Re: Richardson Flats SR-248 Intersection Improvement Project

### **Richardson Flat Road & SR-248 Intersection Improvement Project**

**SR-248 AND RICHARDSON FLAT ROAD  
PARK CITY MUNICIPAL CORPORATION**

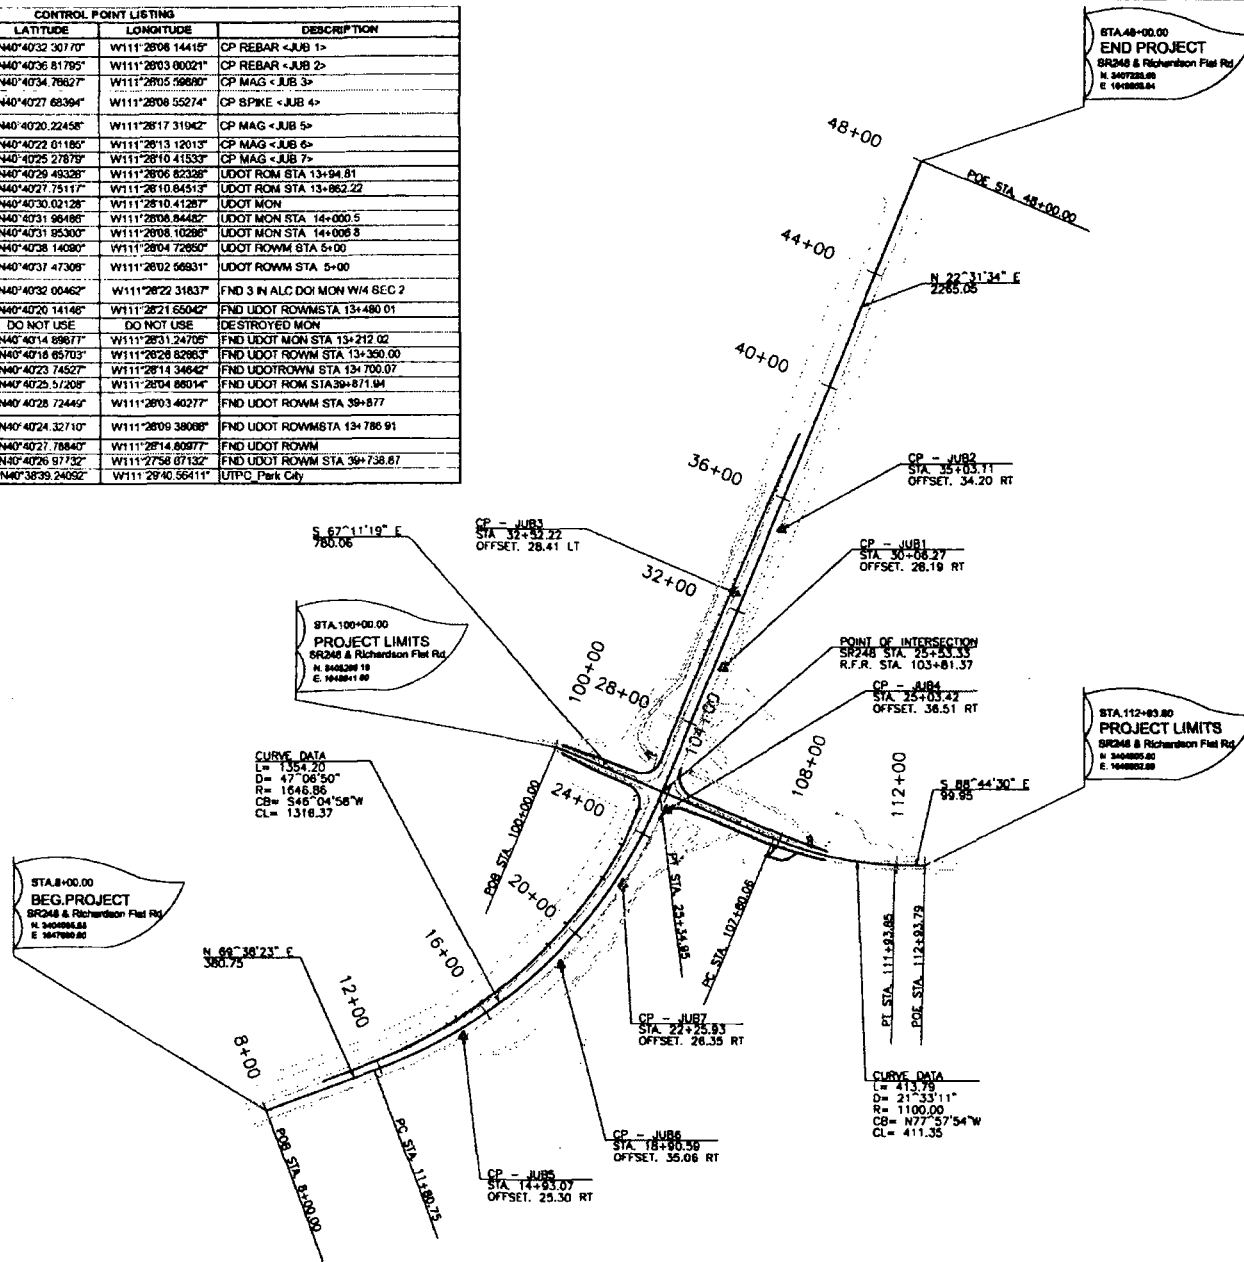
- Information provided does not indicate whether contaminated soil was used as fill material during construction of the original road. If contamination underlies the existing road, planned construction activities for the eastern leg of Richardson Flats Road could disturb such contaminated soil/tailings.

- Information does not allow a determination of how the Homer Pace Irrigation Ditch will be affected by construction activities.
- Information does not allow a determination of how construction activities will encroach toward or potentially impact the Silver Creek floodplain.

- EPA suggests that an appropriate number of soils samples be collected and analyzed within the proposed Zone of Disturbance in the South East quadrant of the intersection. This will confirm the presence or absence of contaminated soils/tailings materials in this area. If contamination is found, then additional alternative intersection designs or remediation may be required.

- EPA requests a complete set of design documents for this project in order to fully evaluate the potential impacts to the Silver Creek Watershed and its associated remedial activities.
